FIAT SERVICE LETTER

SUBJECT: BELL HOUSING GASKET
 VEHICLES: X1/9 AND 128 MODELS
 ENGINE #: STARTING WITH ENGINE #2.989.293

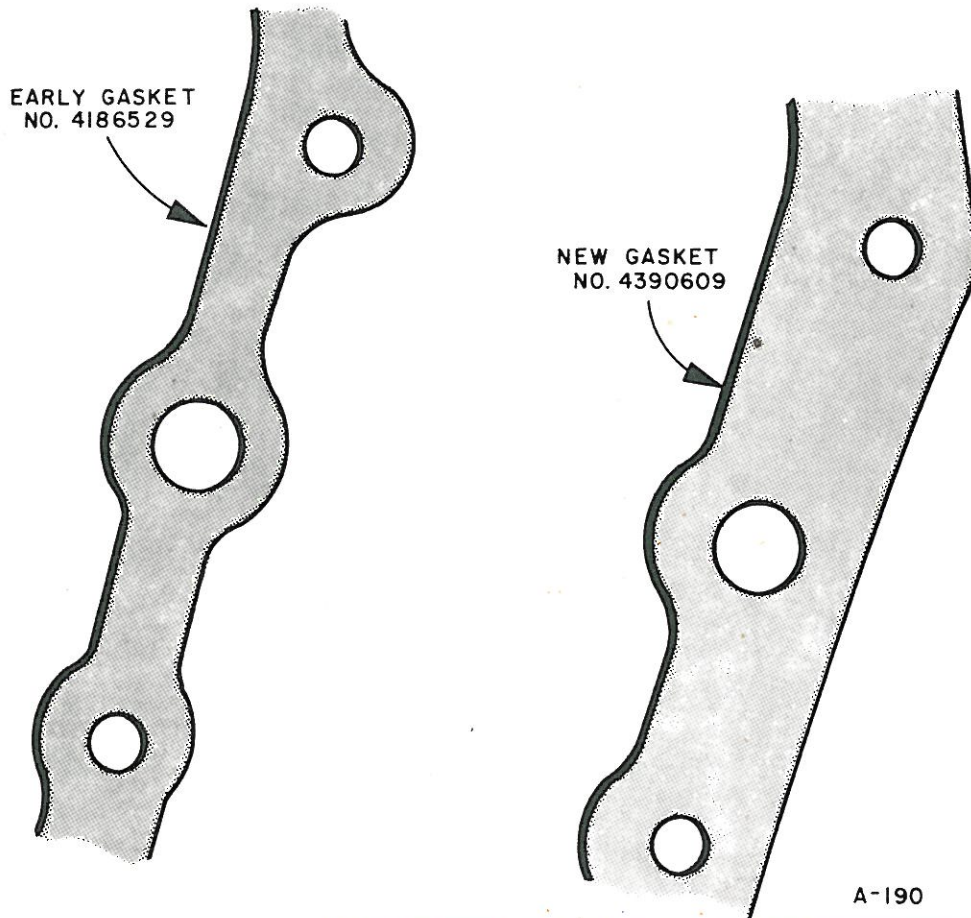
The gasket between the bell housing and transmission case on the above-mentioned models, is wider than the previously installed gasket. (see diagram). This increased width will insure proper positioning of the gasket during installation.

This new gasket can be installed on earlier production vehicles.

The part number for the new bell housing gasket is #4390609.
